Response to ABP Opinion

For a Proposed Strategic Housing Development on
lands at Stepside, Co. Dublin

on behalf of McGarrell Reilly Homes Ltd.

| Project Title | Stepaside SHD | |

Figure 2 Extract from Figure 4.11 of BELAP ('Movement Strategy - Planned Linkages')

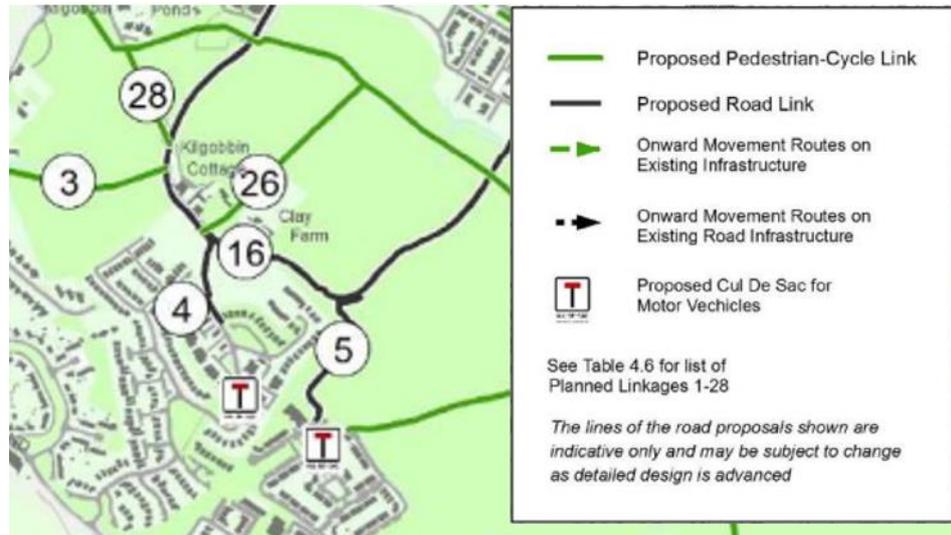
Section 4.3 of the BELAP highlights the overall transportation and movement objective for the area, and in summary seeks to develop a network of interconnected Quarters where walking and cycling shall be suitable as an alternative to the private car, which provides for a permeable, legible pedestrian and cyclist internal and external network.

In order to implement the objectives of the LAP, a number of new and/or improved linkages are required under Policy BELAP MOV12 – New Linkages, which are set out in Table 4.6 of the BELAP.

The linkages from Table 4.6 pertaining to the application site are Link No. 4 'Ballyogan Road to Stepside Park' and Link No. 16 'Clay Farm Loop Road'.

It is noteworthy that Figure 4.11 makes clear *"The lines of the road proposals shown are **indicative only and may be subject to change as detailed design is advanced**"*. (emp. added)

In this instance, although Link No. 4 and the proposed cul-de-sac of the road further to the south do not strictly adhere to the locations shown in Figure 4.11, the associated objective will be achieved. Extension of the Clay Farm Loop Road through the application site will

facilitate direct connections from the established residential area of Stepside Park with Ballyogan Road. In so doing, pedestrian and cycle access will be made available for existing residents to access the Luas, schools, Samuel Beckett Campus and neighbourhood centre facilities. This is in line with the overall transportation and movement objective for the LAP area which seeks to develop a network of walking and cycling routes that will provide an alternative to the private car by providing a permeable, legible pedestrian and cyclist internal and external network which connects existing and proposed residential areas.

Figure 3 Planned Road and Transport Infrastructure from 2016-2022 County Development Plan (Source: BELAP 2019-2025)

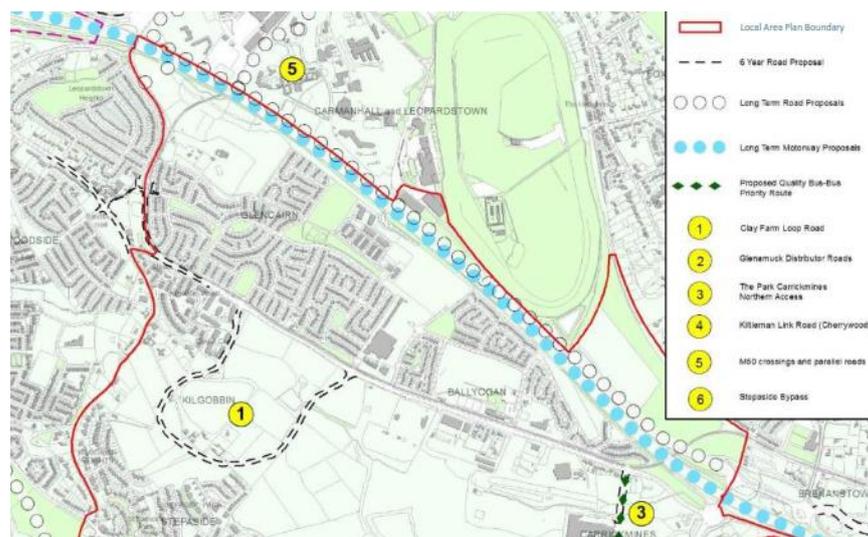
Section 12.1 of the BELAP sets out phasing requirements regarding infrastructure and services. In respect of the Kilgobbin Site Development Framework, it indicates the following requirements regarding Access:

The Kilgobbin lands will be served by the Clay Farm Loop Road. To progress the development of these lands the Loop Road will either be in place, with the necessary legal agreements in place for the developer to access the route, or the Applicant shall provide evidence that the Loop Road will be available to serve the development as homes are completed.

Figure 4.9 of the BELAP shows planned road infrastructure including the Clay Farm Loop Road (as per the DLRCDP 2016-2022). The loop road is indicated as No. 1 on the extract shown below.

This application provides for delivery of a section of the Clay Farm Loop Road which will enable it to be extended further north-west of its currently permitted location within the Clay Farm Phase 2 development to the south-east currently under construction. This proposed extension of the road will facilitate vehicular access to the development site via the Clay Farm / Ballyogan Road / Leopardstown Valley junction along the newly constructed section of the Clay Farm Loop Road.

The applicant is seeking to deliver that portion of the proposed road over which they have control within the application site boundary. This approach will enable delivery of a further section of the road, a vital piece of enabling infrastructure which will contribute to unlocking the development potential of the wider zoned lands in Kilgobbin South.
